WISCONSIN ELECTRIC POWER COMPANY
DOCKET NO. 50-266
POINT BEACH NUCLEAR PLANT, UNIT NO. 1
AMENDMENT TO FACILITY OPERATING LICENSE

Amendment No. 51
License No. DPR-24

AMENDMENT NO. 51 TO FACILITY OPERATING LICENSE NO. DPR-24

AMENDMENT NO. 57 TO FACILITY OPERATING LICENSE NO. DPR-27

Figure 15.3.1-3/PBMP Unit No. 2
 Heatup Limitations Applicable to
 14 Effective Full Power Years
 (Approximately September 1990)
 Instrument Error Included

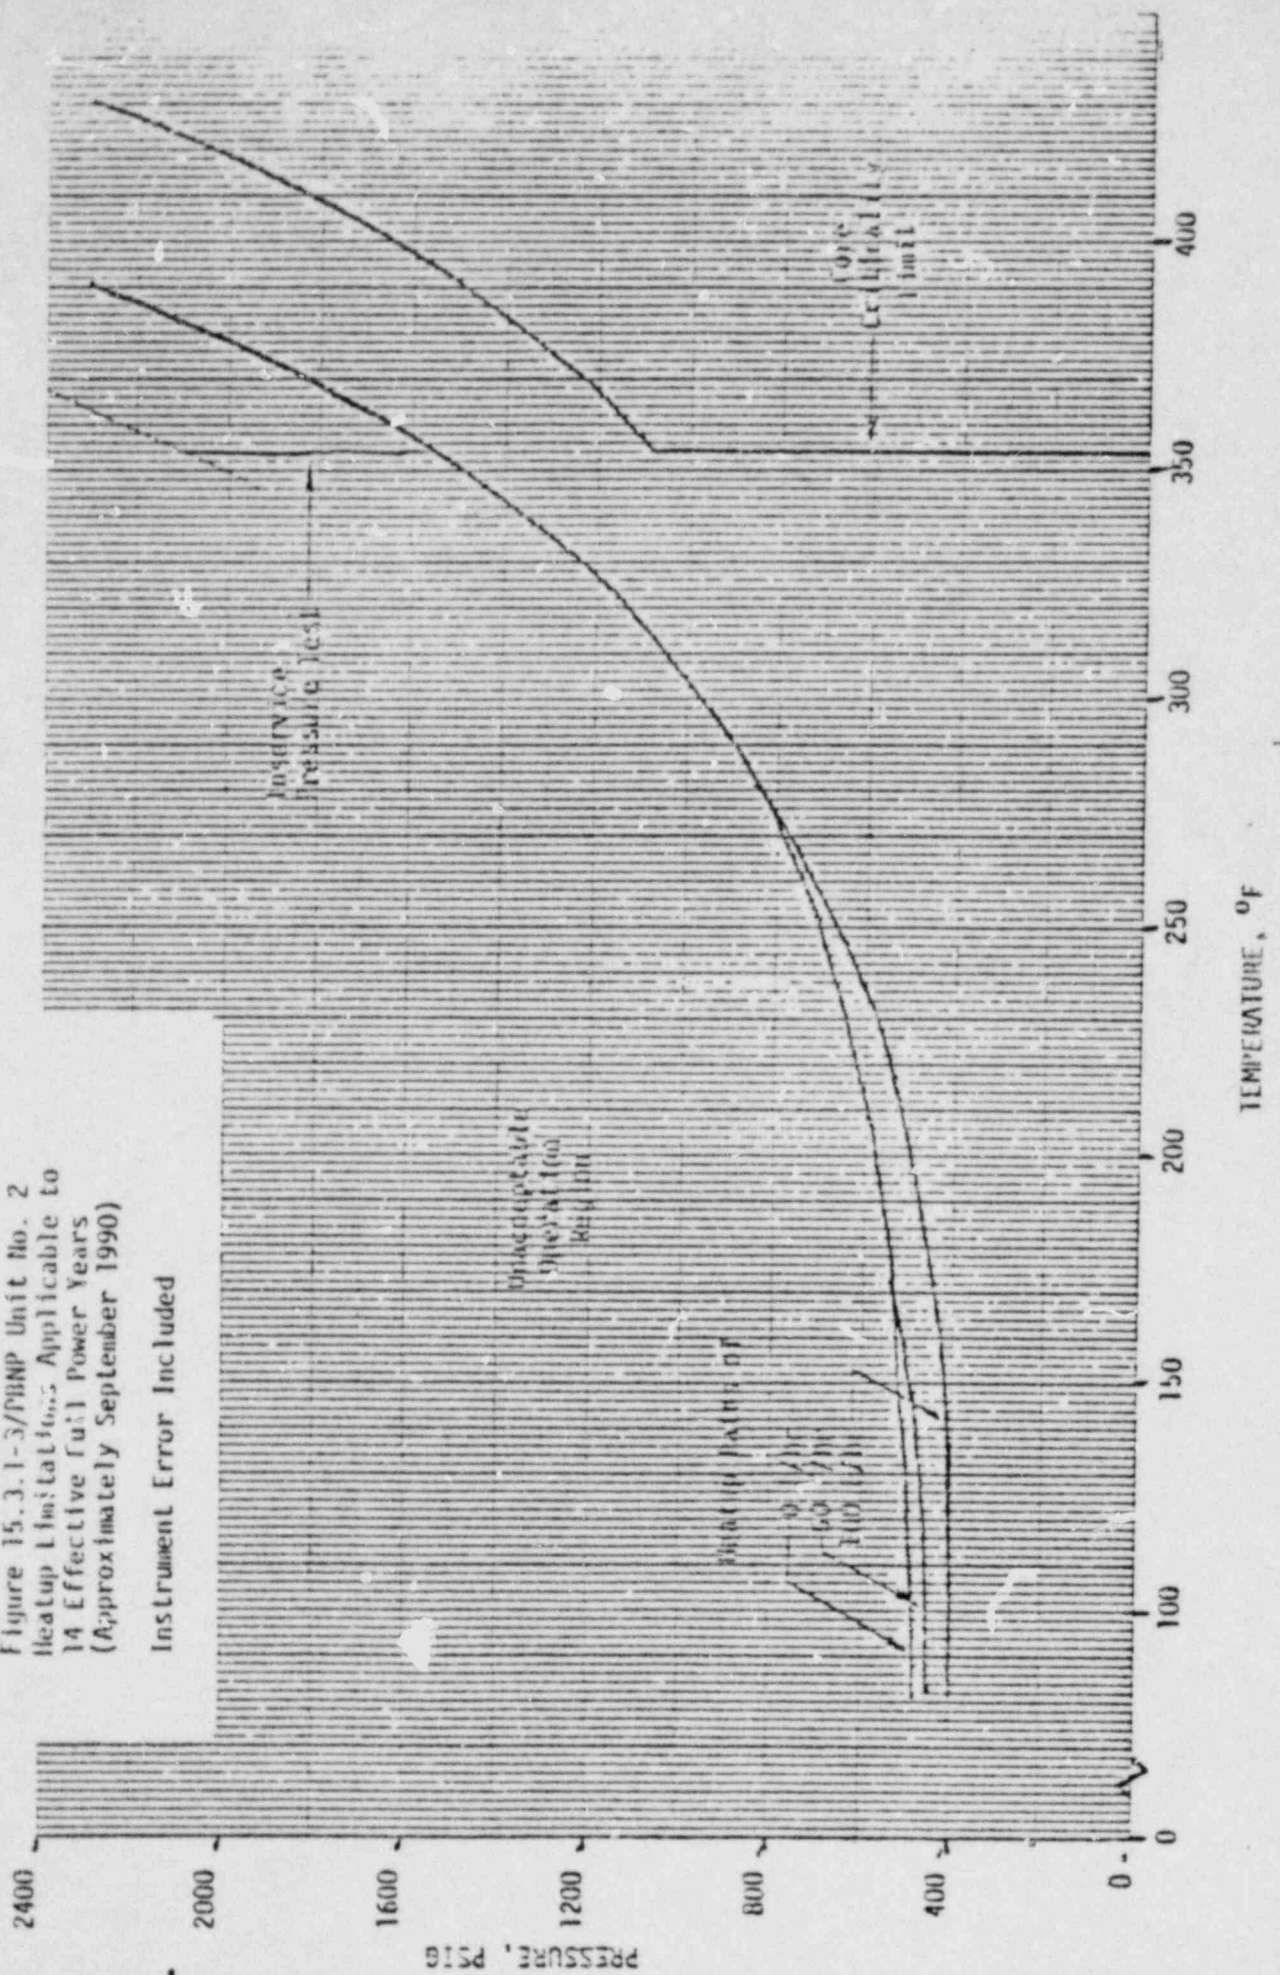
The heatup and cooldown curves presented in Figures 15.3.1-1 and 15.3.1-2 (Unit 1) and 15.3.1-3 and 15.3.1-4 (Unit 2) were calculated based on the above information and the methods of ASME Code Section III (1974 Edition) Appendix G, "Protection Against Nonductile Failure", and are applicable up to the operational exposure indicated on the figures. Corrections for possible instrumentation inaccuracies have been incorporated into these curves. The temperature correction is made by adding the temperature error (24°F, Unit 2) to the required temperature and the pressure correction is made by subtracting the pressure error (64 psi, Unit 2) from the required pressure. These corrections adjust the curves in the conservative direction.
